Memorandum

Subject: Variance Request to Permit and Install a New Individual Sewage Disposal System (ISDS) on an Undersized Lot Served by an Off-Site Public Water Supply with a Shallow Absorption Field within Eight (8) Feet of a Structure and Ten (10) Feet of the Property Lines (APN 129-36-101-014)

BACKGROUND

Attachment F: ISDS Density Map

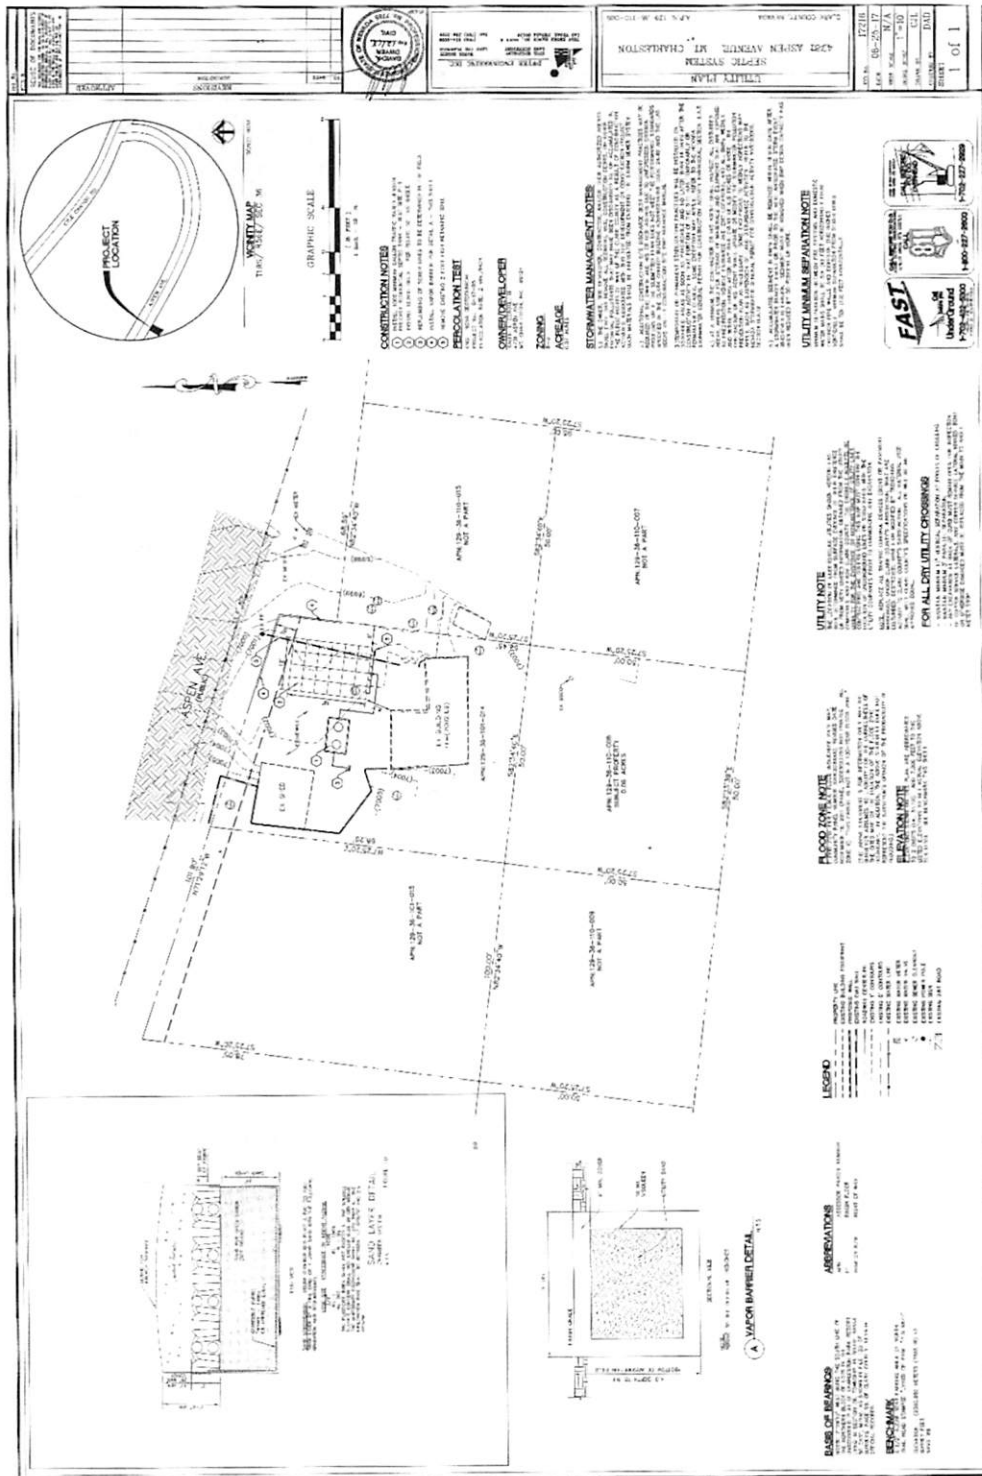
There are two existing wells located upgradient and the closest well is within seven hundred (700) feet of the proposed shallow absorption system. The ISDS density map also shows "189 Lots with a traceable permit for a septic system within a square mile of APN 129-36-101-014." The offsite water quality will most likely not be affected by the proposed septic system. The closest neighboring building to the proposed ISDS is a distance of forty five (45) feet, where eight (8) feet minimum is required.

Attachment G: Utility Plan

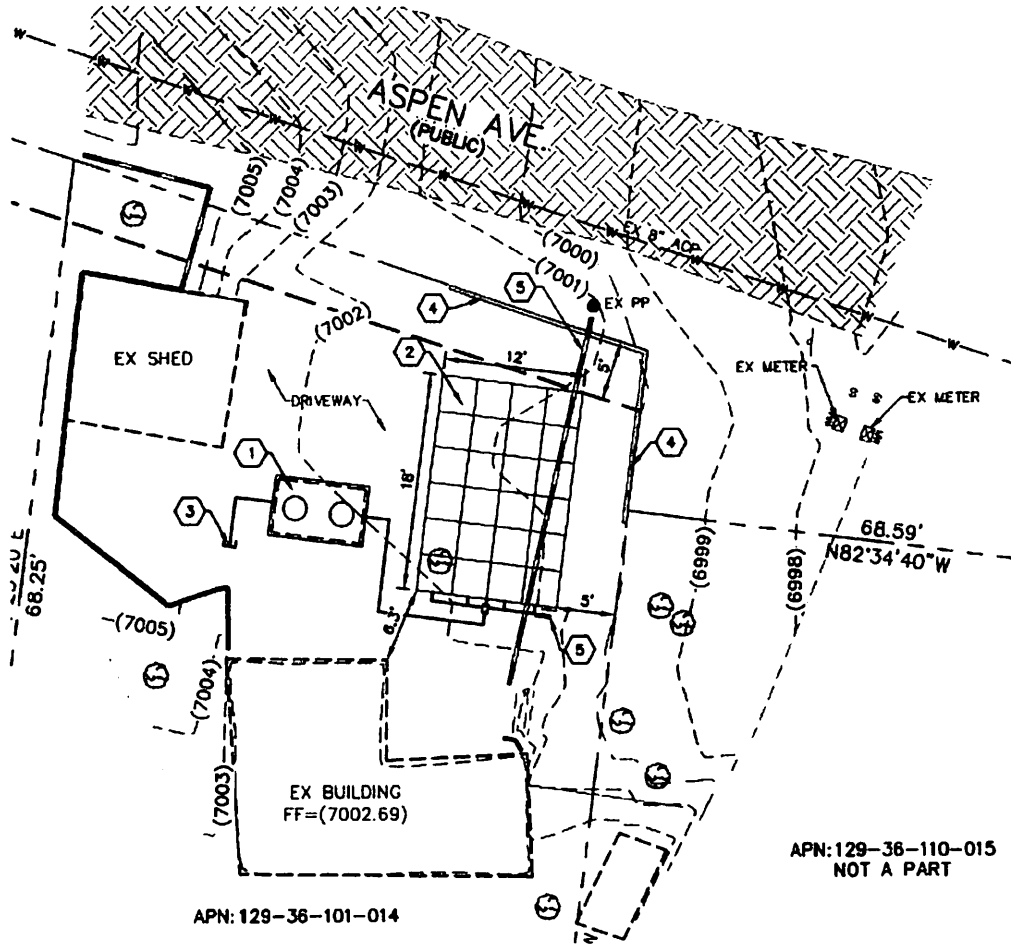
1. The ISDS will be limited to the proposed 1,000 gallon traffic rated septic tank with the proposed chamber leach field as shown in the attached Utility Plan.

2. The proposed absorption field may not be located in an area that is: subject to vehicular traffic, to be paved, or within ten (10) feet of any tree.
